UNITED STATES PATENT AND TRADEMARK OFFICE

Office Action Summary	Application No. 10/541,297	Applicant(s) KRESS, JURGEN	
	Examiner ALIREZA NIA	Art Unit 3739

DETAILED ACTION

Inserted image 1: Fig. 4 from Silverstein 4,646,722

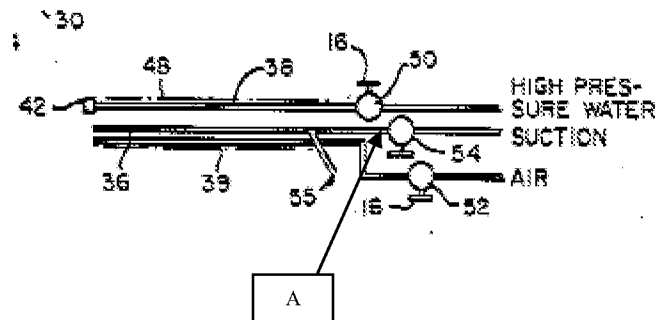
3. Regarding claims 29-38, 41-42, and 46, Silverstein discloses an endoscope 8 with hygiene protection 10,30, comprising a cover 10,30 closed at a distal end 32 and transmissible for optical information via 32,44,46, at least on a front face 32 of said cover 10,30, and capable of being rolled via 48 in an axial direction of said endoscope 8, a working channel 38 extending parallel to said endoscope 8 via 21 and terminating in an open mode via 40,42 at said distal end 32 of said cover 10,30, said working channel 38 being connected only to said distal end 32 of said cover 10,30 and positioned between an outer side 12 of said endoscope 8 via 21 and an inside of said cover 10,30 (col. 6, lines 16-46, 58-68, col. 7, lines 1-14, 41-54, figs. 1-3), and a vacuum channel 36, having at least one opening A (A is an opening since it opens and closes via valve 54) (see inserted image 1 below), and terminating at said inside of said cover 10,30,48 via 12,14 (since 48 covers and isolates the entire endoscope 8,12,14) with said at least one opening A terminating via 54 inside of said cover 10,30,48 via 12,14 in a direction facing said endoscope 8 (the direction is facing endoscope 8 and portion 14 of endoscope 8), said vacuum channel 36 being a channel that is a different channel from said working channel 38 (fig. 4). Silverstein

further discloses means 64 for varying cross-sectional diameter via 48,60 (col. 7, lines 47-60), wherein said cover 10,30 includes a material 48 that is airtight, watertight and impermeable to pathological microorganisms with connection of said cover 10,30 to said working channel 38 to said distal end 32 of said cover 10,30 being made airtight, watertight and impermeable to pathological microorganisms (col. 6, lines 35-46), wherein said cover 10,30 is flexible and elastic and foldable in the axial direction of said endoscope 12 via 48 (col. 6, lines 58-68), wherein at least a portion of said cover 10,30 inherently has an internal diameter that is larger than an external diameter 12 of the endoscope 8. Silverstein further discloses a transparent pane or lens 32,44,46 on said distal end 32 of said cover 10,30 on said front face 32 of said cover 10,30 (col. 6, lines 47-57), wherein said transparent pane or said lens 32,44 at least partially forms said front of face 32 of said distal end 32 of said cover 10,30 via 46, wherein said distal end 32 of said cover is an optically transparent cap via 32,44, wherein said distal end 30,32 of said cover 10,30 has a wall thickness that is greater than wall thickness of a non-distal region 48 of said cover 10,30, wherein said cover 10,30, when open at a proximal end 48, is fixable to be airtight on a shaft 12,14 of said endoscope 8 via 48 (col. 6, lines 62-68), wherein said vacuum channel 36 extends for at least a portion of a length of said cover 10,30. Silverstein further discloses means (suction, fig. 4) for applying sub-atmospheric pressure to said at least one vacuum channel 36 during use of said endoscope 8 (col. 6, lines 28-35). Silverstein further discloses depressions 21 in an axial direction on an outer surface of said endoscope 8 (col. 6, lines 16-21), wherein said working channel 38 and said vacuum channel 36 are fixed to said distal end 32 of said cover 10,30 via 40,42 (col. 6, lines 29-45).

4. With respect to claims 47-48, Silverstein discloses attaching a hygiene protection 10,30 to an endoscope 8, said endoscope 8 including a cover 10,30 closed at a distal end 32 and transmissible for optical information via window 32,44, at least on a front face 32 of said cover 10,30, and capable of being rolled via 48 in an axial direction of said endoscope 8, a working channel 38,39 extending parallel to said endoscope 8 via 21 and terminating in an open mode 42 via 40 at a distal end 32 of said cover 10,30, said at least one working channel 38,39 being connected only to said distal end 32 of said cover 10,30 and positioned between an outer side 12 of said endoscope 8 via 21 and an inside of said cover 10,30,48, a vacuum channel 36, having at least one opening A (A is an opening since it opens and closes via valve 54) (see inserted image 1 below), and terminating via 54 at said inside of said cover 10,30 via 48 (since 48 covers and isolates the entire endoscope 8,12,14) with said at least one opening A terminating inside of said cover 10,30 via 48 in a direction facing said endoscope 8 via 14 (the direction is facing endoscope 8 and portion 14 of endoscope 8), said vacuum channel 36 being a channel that is a different channel from said working channel 38 (col. 6, lines 30-46, fig. 3), said method comprising the steps of coating an inner side of said window 32,44 at said distal end 32 of said cover 10,30 for producing optical contact between said window 32,44 and an optical channel of said endoscope (col. 6, lines 52-57), introducing a distal end of said endoscope 8 into said cover 10,30, said cover being open at a proximal end 48 and closed at said distal end 32 thereof, rolling said cover 48 onto, or unfolding said cover 48 with, an enclosure 12 of said endoscope 8 and said working channel 38 via 21, and applying a sub-atmospheric pressure via (suction, 54, see fig. 4) to said vacuum channel 36, fixing said working channel 38 at said distal end 32 of said cover

10,30 via 40,42, said working channel 38 being positioned in depressions 21 provided on an outer surface 12 of said endoscope 8 and said working channel 38.
